RE: P.Z. 05-2023 Wings Corporate Estates, Lot 5 (Wings & Wheels of Chesterfield LLC): A request to rezone an existing "PI" Planned Industrial District to a new "PI" Planned Industrial District for a 1.3-acre tract of land located northeast of the intersection of Wings Corporate Drive and Buzz Westfall Drive (17W120087).

RE: Wings Corporate Estates, Lot 5 (Wings & Wheels of Chesterfield, LLC)

RE: Wings Corporate Estates, Lot 5 (Wings & Wheels of Chesterfield LLC): Issues Response Letter
(Stock Project No. 222-7353)

SHEET NO.: PDP-1.0

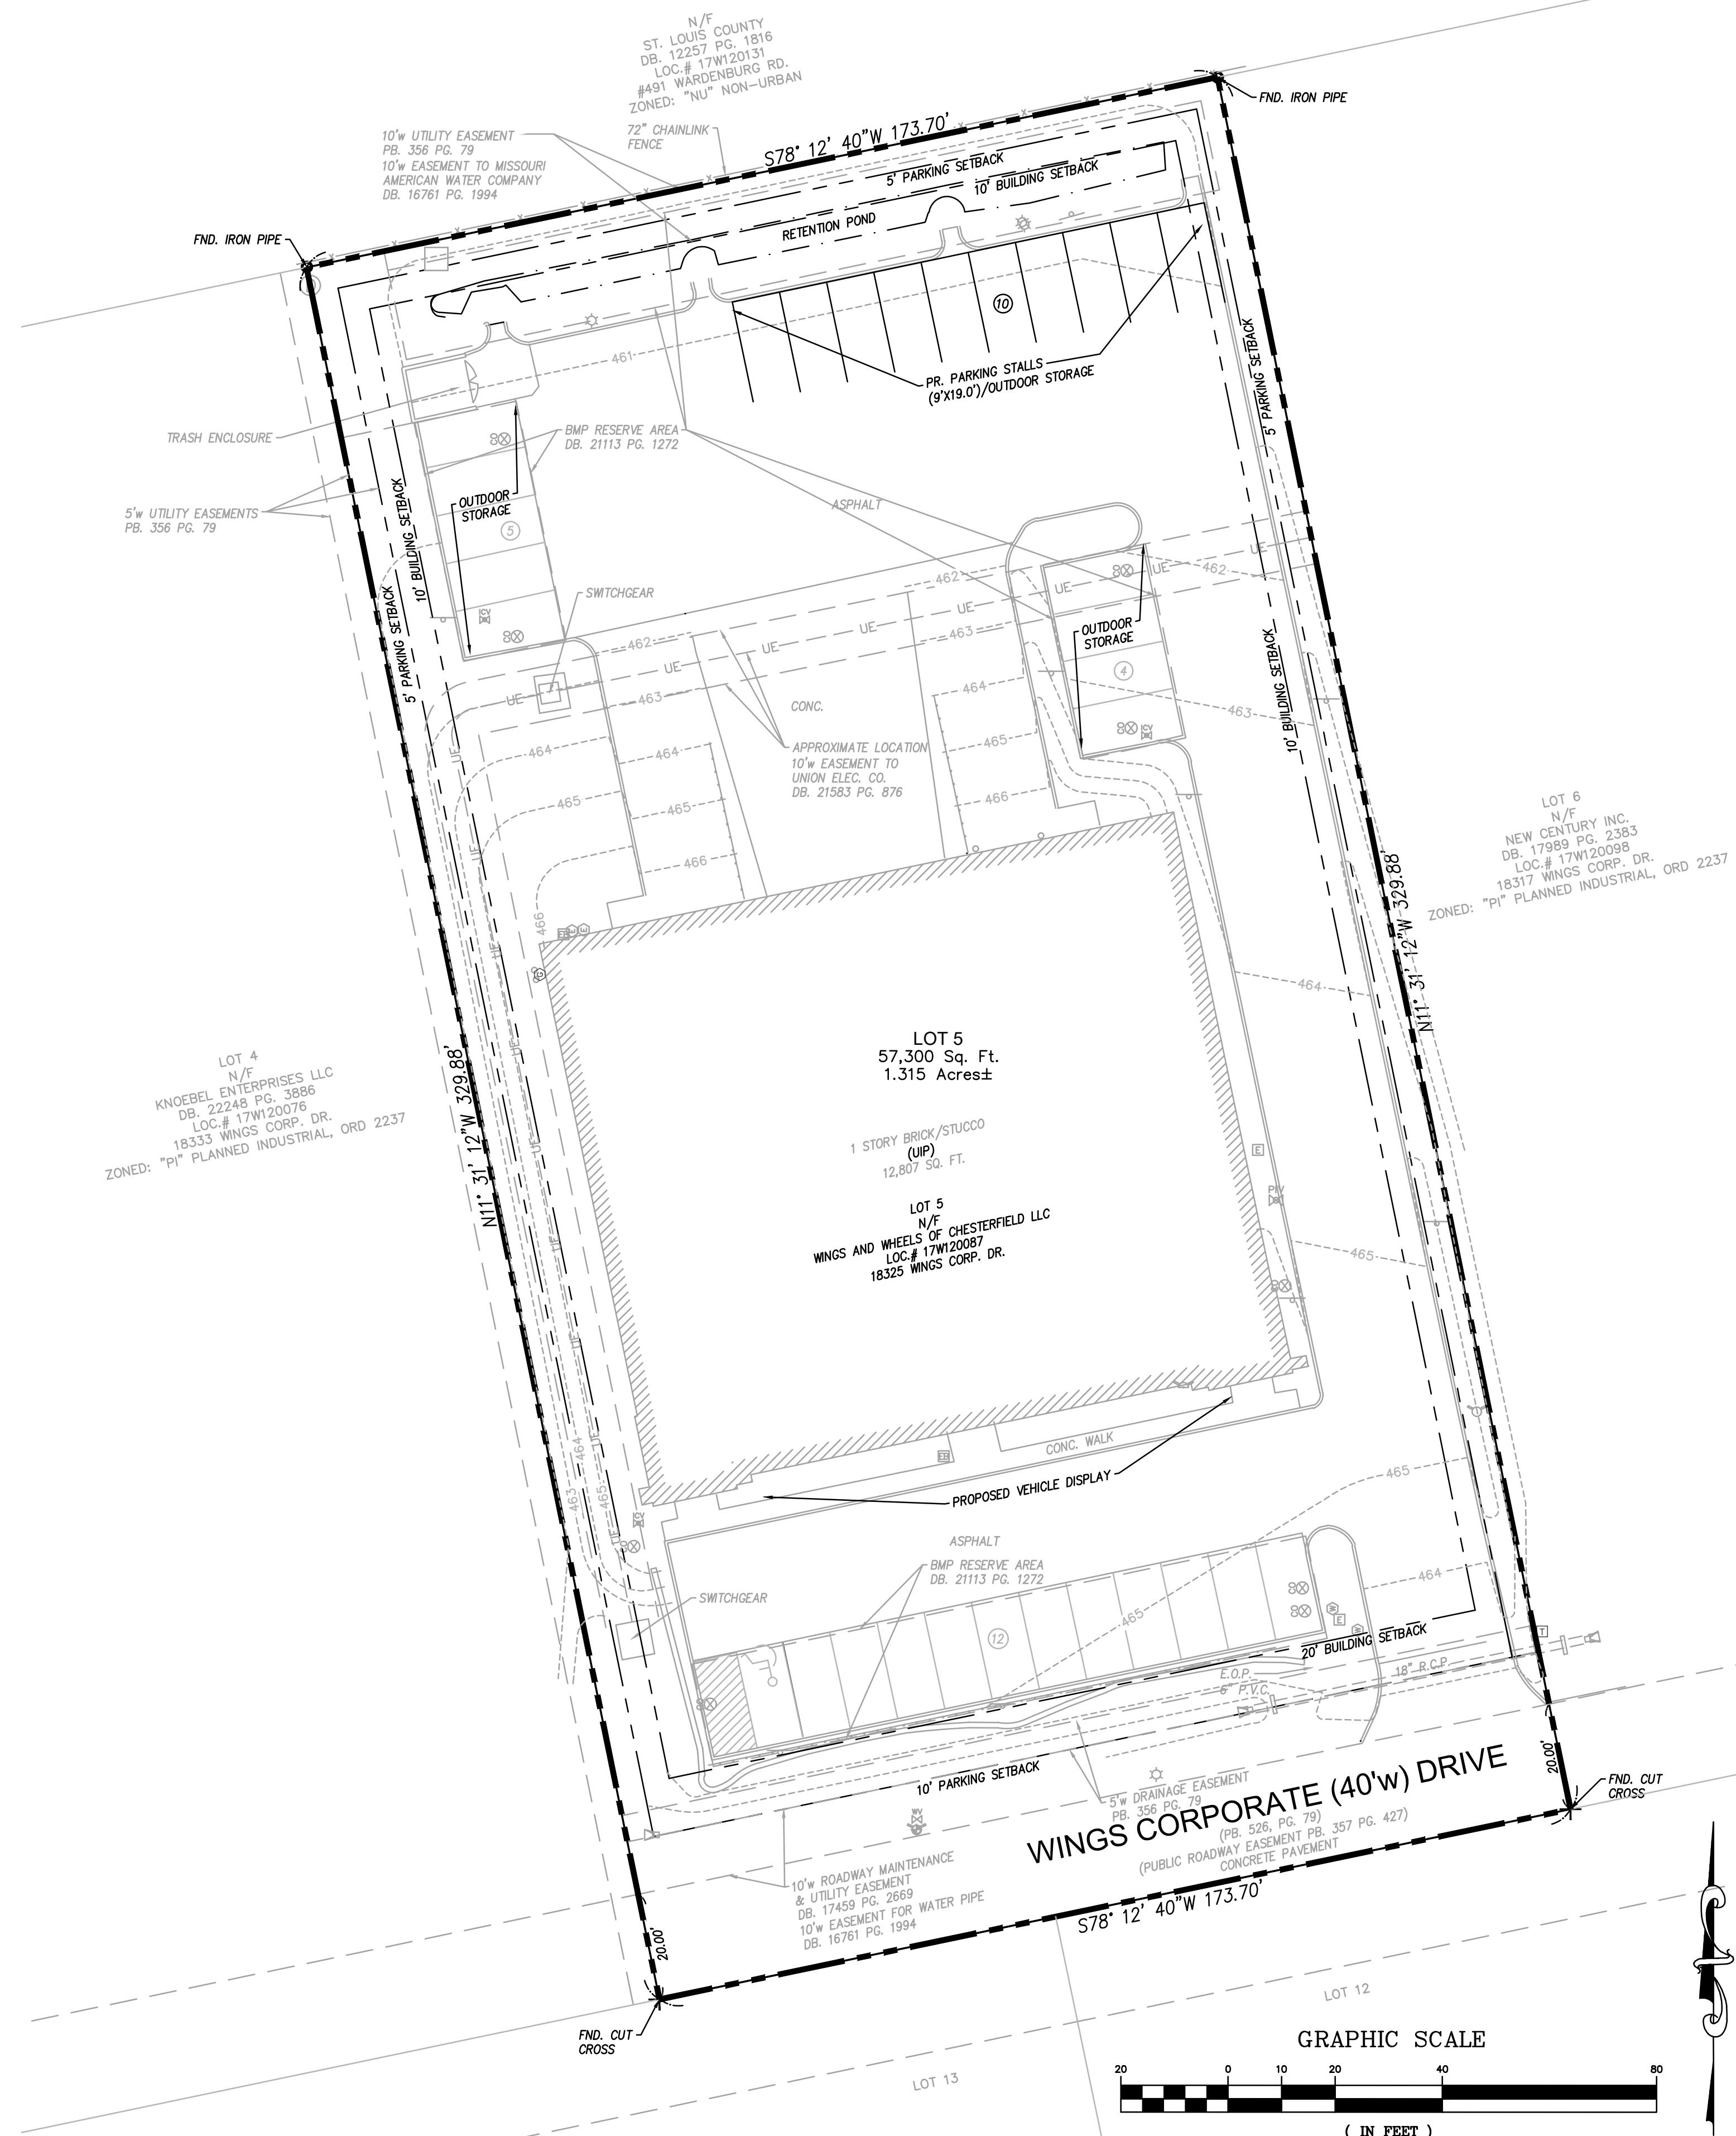
- 3) The topic of outdoor storage and display was discussed. Provide a response detailing the property owner's plans for storage and display for the site. If areas of outdoor storage or display are desired, they need to be delineated on the preliminary development plan.

- 4) The existing entrance is gated. The gate is not shown on the ALTA Survey or Preliminary Development Plan. The existing gated entrance was not previously approved by the City and does not appear to meet City requirements for a minimum 60-foot stacking length nor include provisions for a rejected vehicle to turn around. Please provide information on how this issue will be addressed. Requirements for a gated entrance can be found in [City Code § 405.04.100\(D\)\(6\)](#), Driveway Access Location and Design Standards.

- 7) Delete "General Notes" #8. There are no regulatory floodplain or CVSWMP features on Lot 5.

3. **Issue:** The topic of outdoor storage and display was discussed. Provide a response detailing the property owner’s plans for storage and display for the site. If areas of outdoor storage or display are desired, they need to be delineated on the preliminary development plan.

7. **Issue:** Delete “General Notes” #8. There is no regulatory floodplain or CVSWMP features on Lot 5.

Applicant Response: Please see Preliminary Development Plan for areas delineated as “outdoor storage” and “display”. The vehicle display area will be along the front (south face) of the existing building. Display vehicles will be returned inside at the end of each business day. Outdoor Storage will be located in the rear of the site (north of the existing building) and comply with the City’s requirements for screening.

Applicant Response: The property description on the Preliminary Development Plan has been revised to correct the error in the “township”.

Applicant Response: General Notes #8 has been removed from the Preliminary Development Plan.
